AGENDA
PLANNING AND ZONING COMMISSION MEETING
CITY OF CREVE COEUR, MISSOURI
TUESDAY, JANUARY 21, 2020
6:30 PM

1. PUBLIC HEARING. Application #19-043: The Review and Adoption of the 39N Greenway Plan as an Amendment to the 39 North Master Plan and the Creve Coeur 2030 Comprehensive Plan

2. Applications #19-046 & #19-047: Approval of a Boundary Adjustment and a Site Development Plan for a 20 Unit Apartment Building at 10809-10819 Olive Boulevard

Alvah Levine, of Levine Associates, on behalf of JLA Group, LLC, has submitted an application for Site Development Plan approval for a 20 Unit, 2-bedroom apartment building at 10809-10819 Olive Boulevard. Medium Density Multifamily Residential (up to 20 units per acre) (NAICS-CC814120) Developments are a permitted use in the CB-Core Business District. The Boundary Adjustment will consolidate the three lots into one development for a total of 1.05 acres.

Figure 6: Close-up of the site plan where greater pedestrian interest needs to be provided.

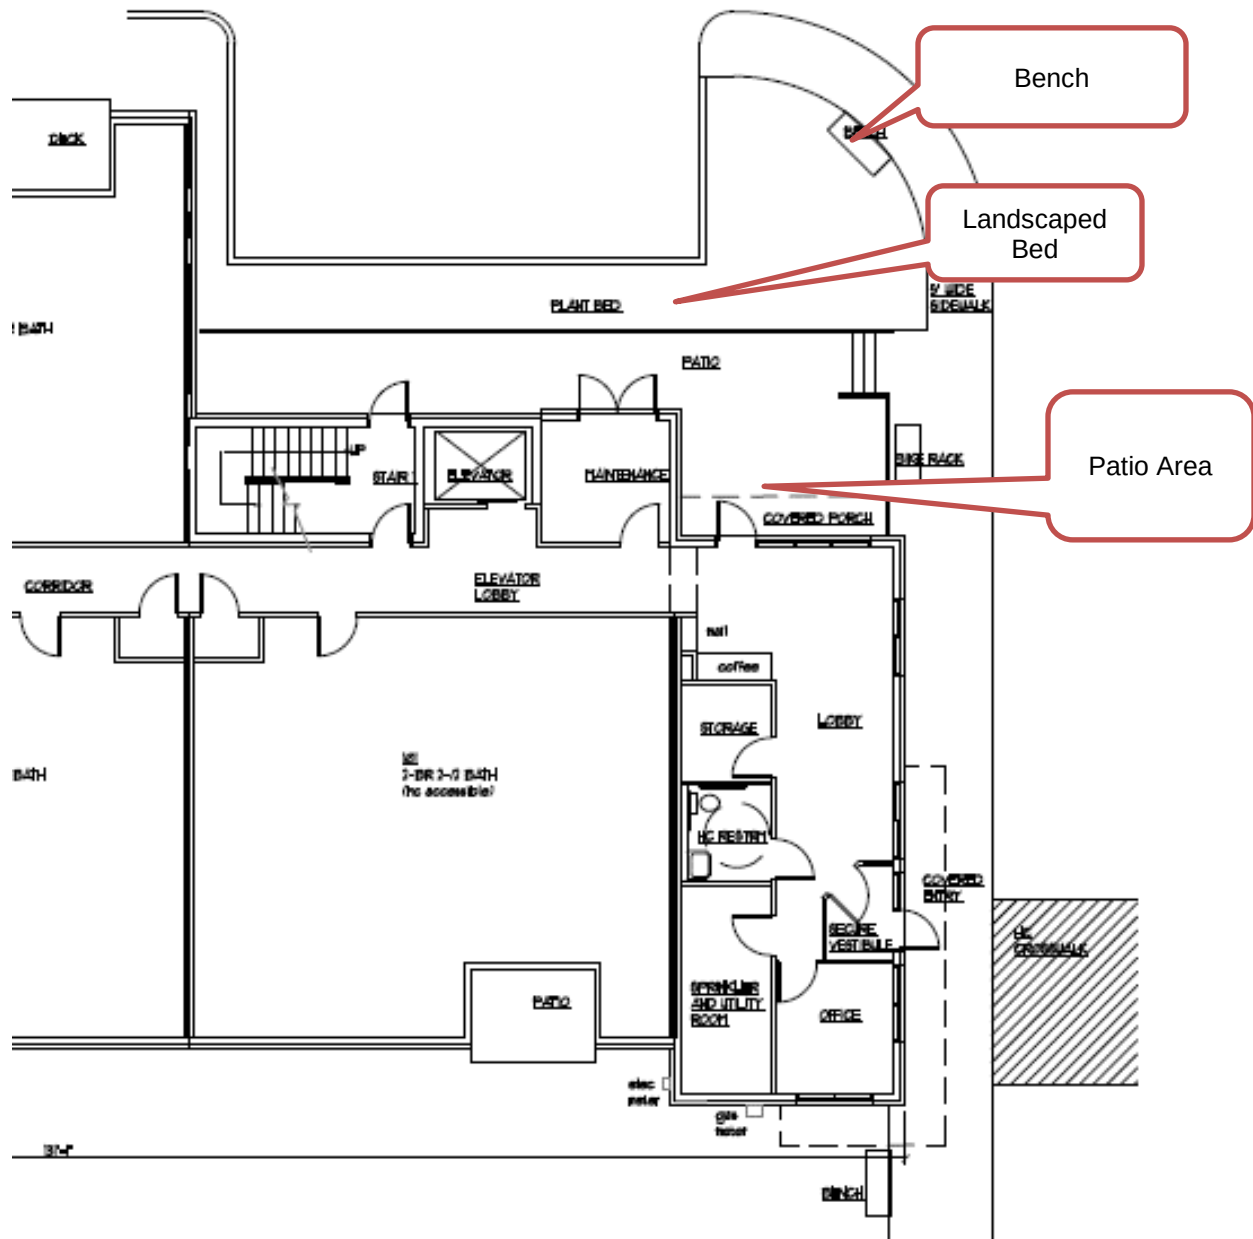
parking to the north elevation to the lobby/entrance need to provide better connections as opposed to just ending at the parking lot, and the placement of a single bench within the landscaping seems poorly placed. A better integrated outdoor amenity space in this area would elevate the overall design of the area.

Figure 7: Applicant's Carport and Trash Enclosure Elevations

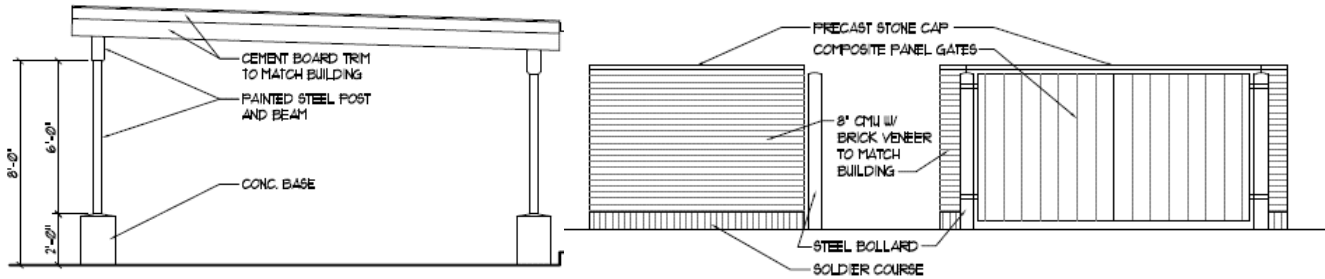
Additionally, the City's Design Guidelines strongly encourages high quality landscaping that accentuates the building and site. Accessory Buildings and Facilities are to be designed to directly relate in material, character and detail to the primary building on the site, as well as the design of fencing, sound walls, trash enclosures, and similar site elements is to be compatible with the architecture of the main buildings and should use similar materials. The Design Guidelines state that Multi-Family Developments shall provide underground parking or parking within a basement garage for at least 50% of the required vehicular parking (p. 13). This also cross references a prior Zoning Ordinance, for the conditional uses for multi-family developments which now states that at a minimum, seventy percent (70%) of the required vehicular parking shall be provided within a parking garage or structure that is aesthetically integrated into and incorporates architectural features of the principal structure. While the proposal is not a conditional use, and thus the 70% of parking within a parking garage is not required, the Applicants are providing 50% of the parking under carports, that are appropriately placed to the rear and side of the building, behind the front building line. However, the proposed carports lack the design consideration relating to the basic structure. Greater design consideration should be provided to the column, instead of the painted steel post and beams on a concrete base. As an alternative, Staff recommends that the posts be wrapped in a durable material similar to the building and have a darker tone to blend into the site, for a smoother appearance. An example of this recommendation is provided in Figure 8, below.
